CAYMAN SECTION 4 PHASE 2

**SUBMITTED TO DRAINAGE
BOARD SEPTEMBER 1, 2015**

Cayman Section 4 Phase 2-FINAL DRAINAGE PLAN

INTERMITTENT STREAM 1 -
PROPOSED PLANFORM
AND PROFILE

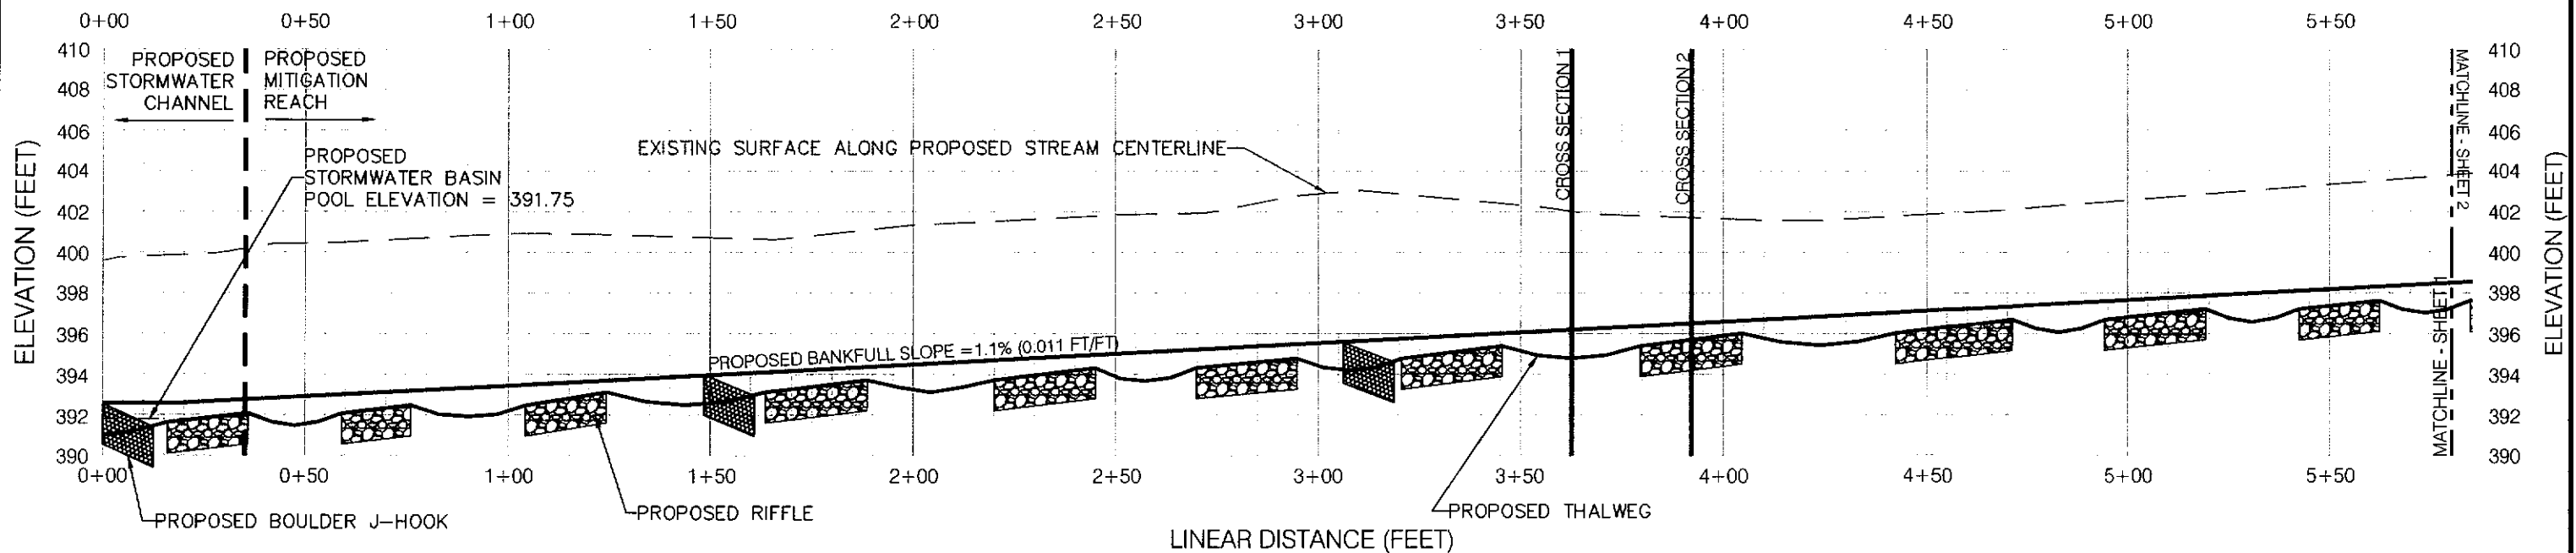
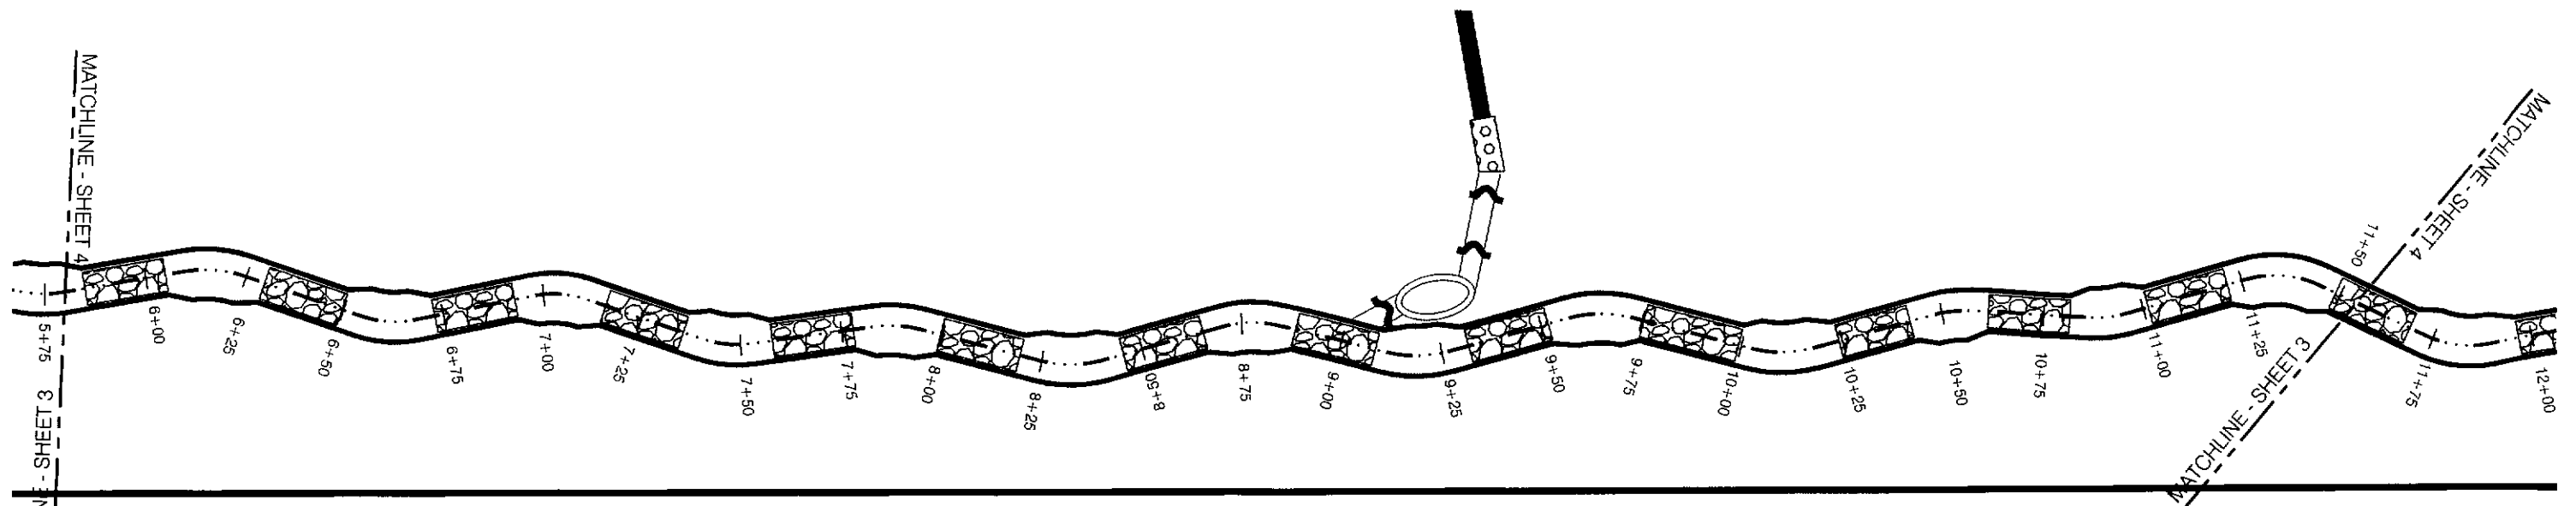
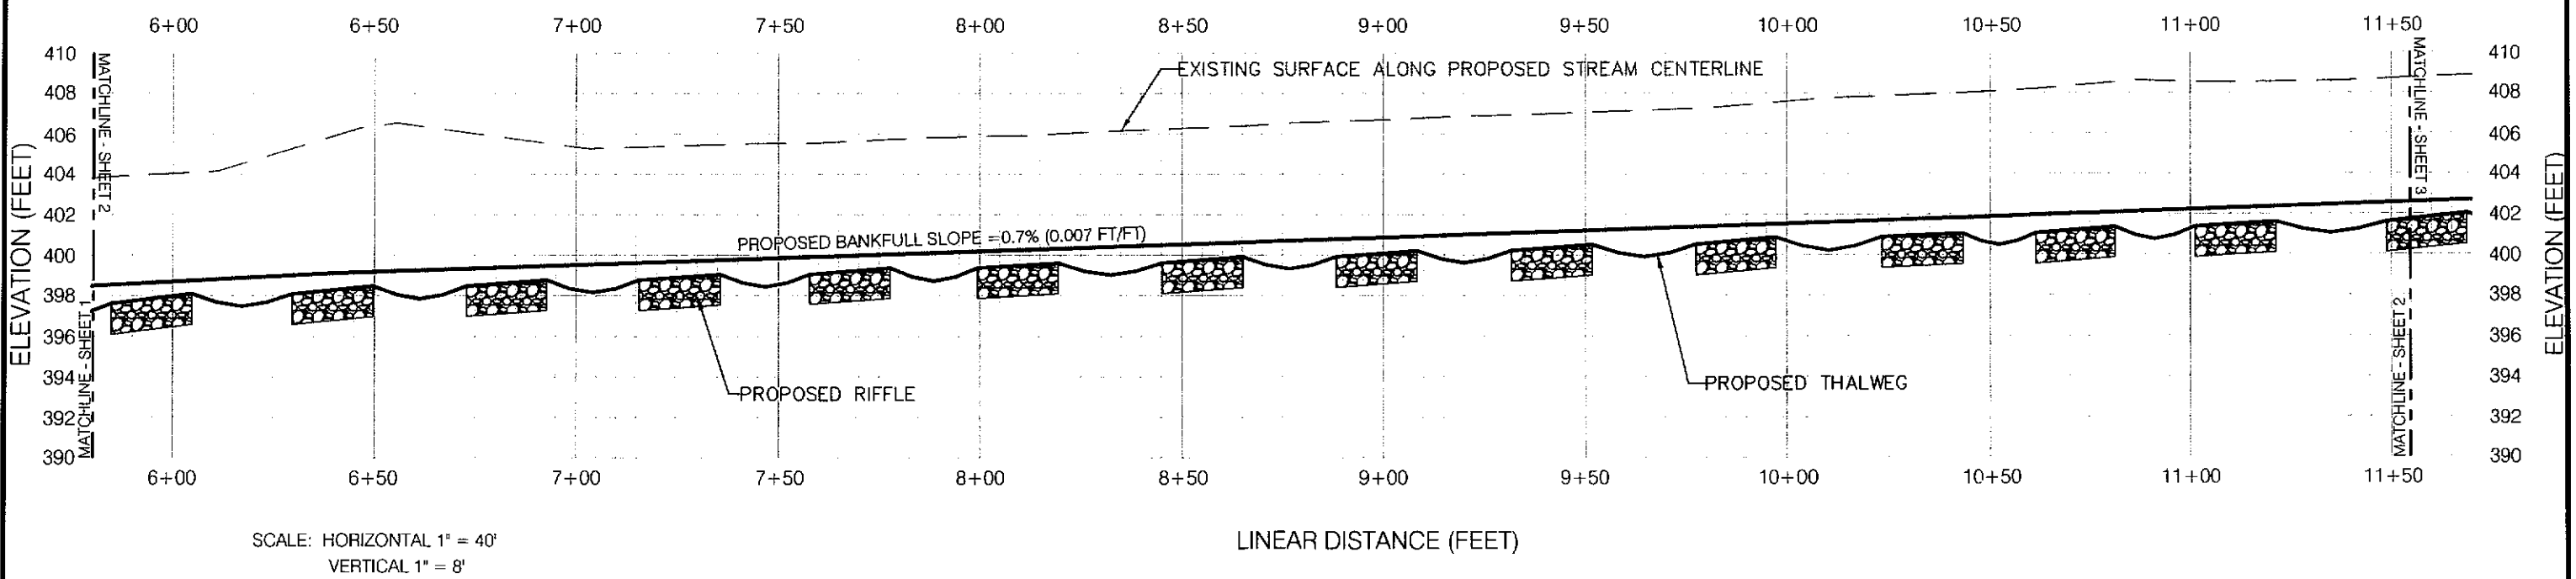
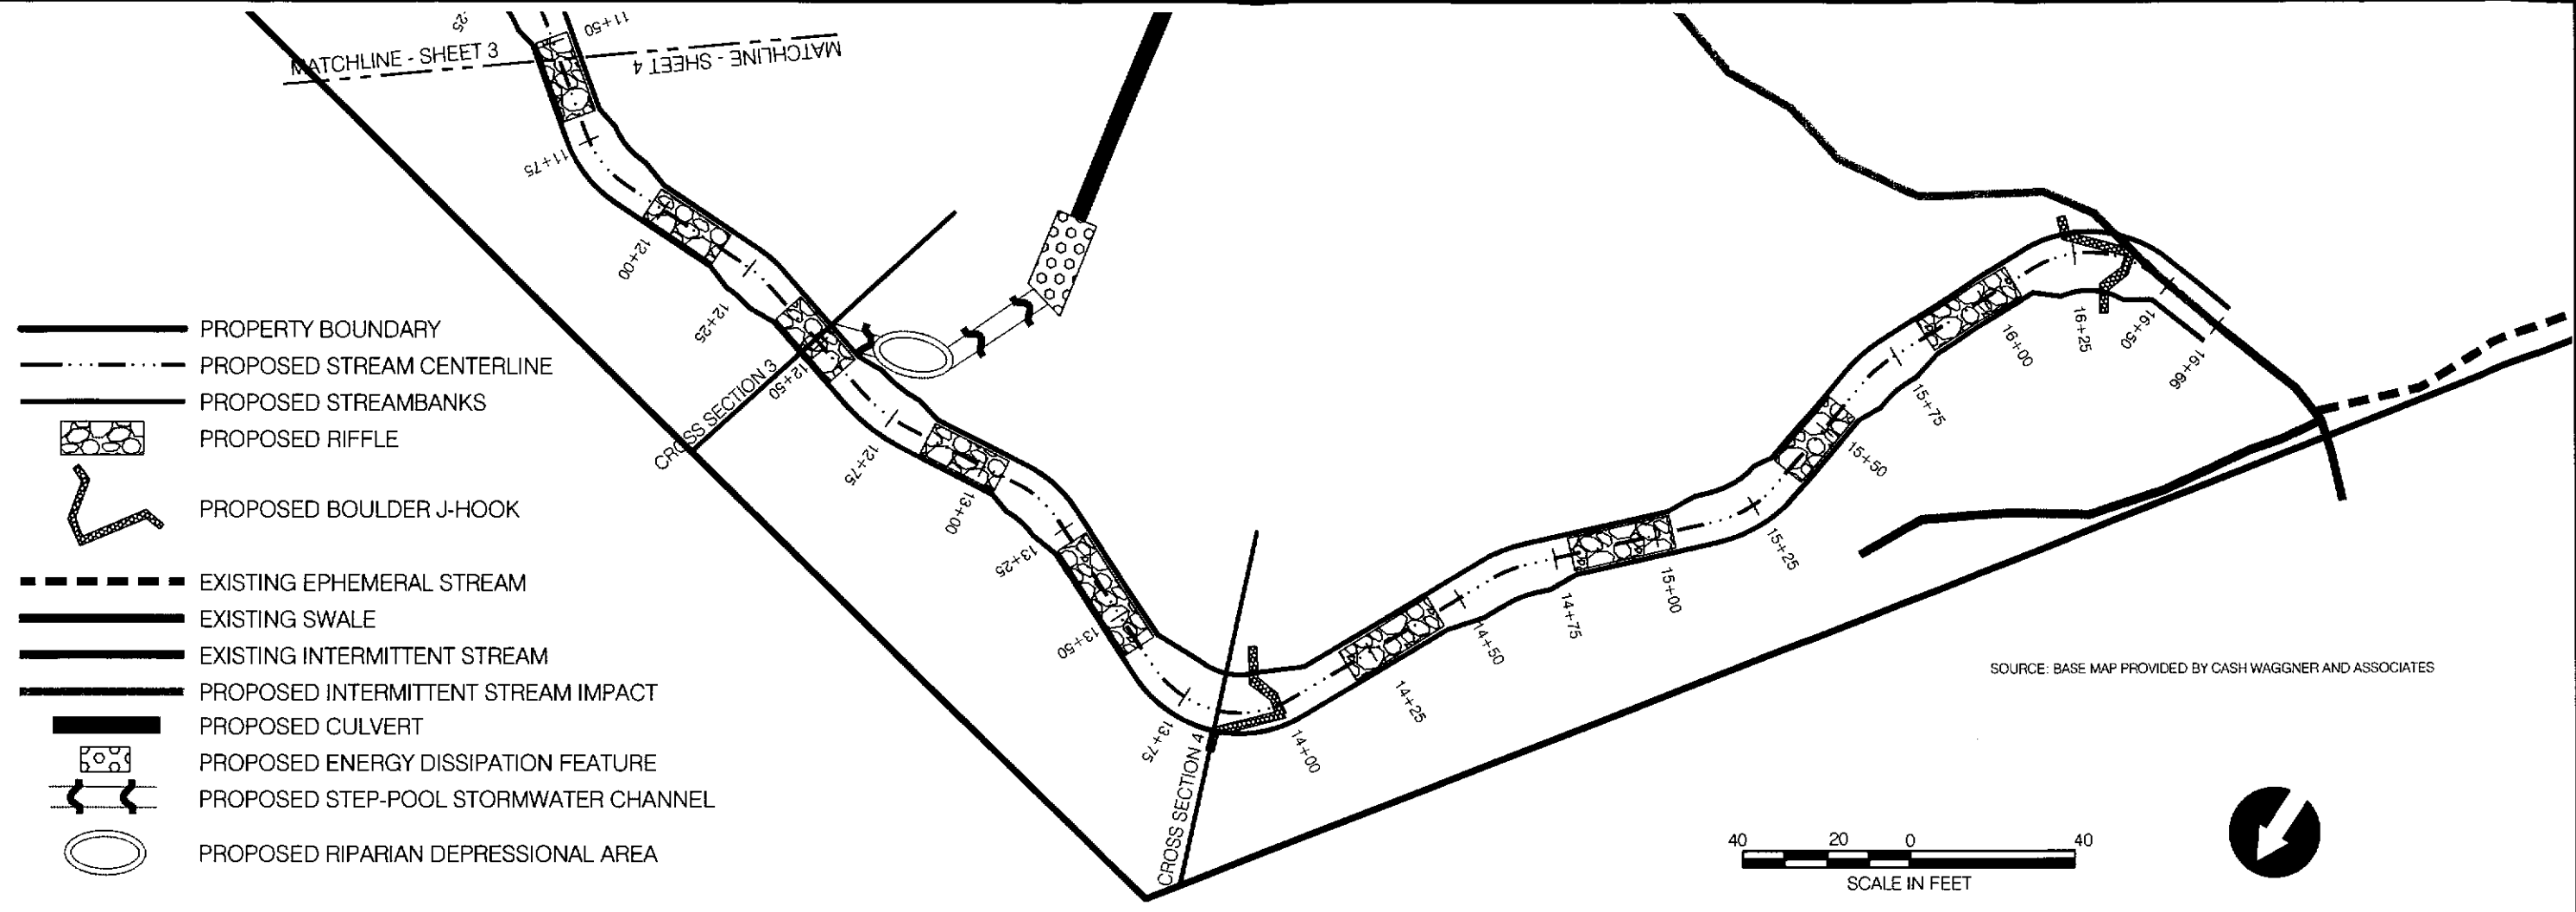
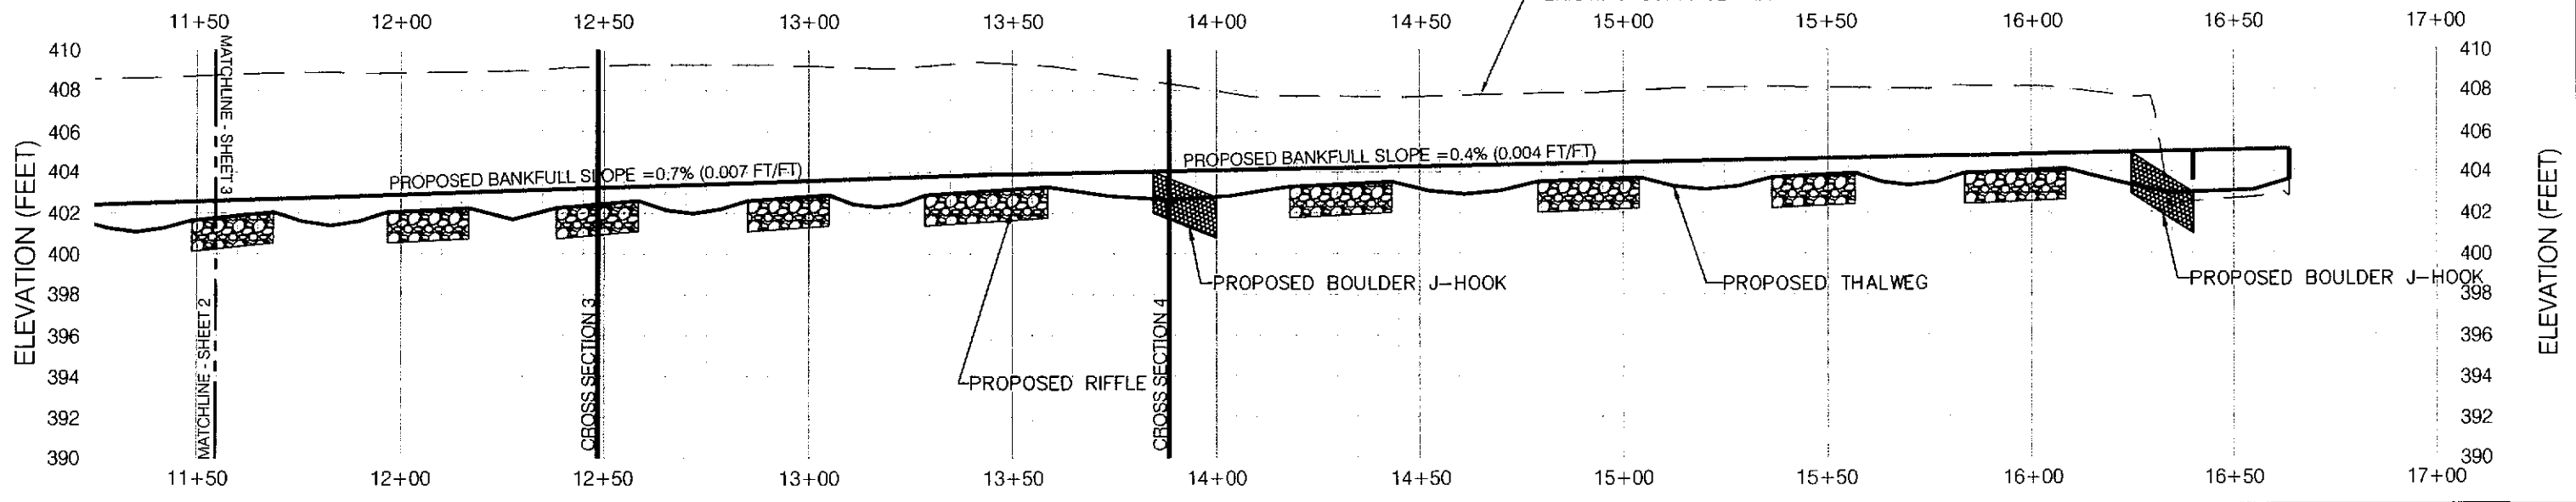
What is the design criteria for the relocated channel as submitted to USCOE? Provided
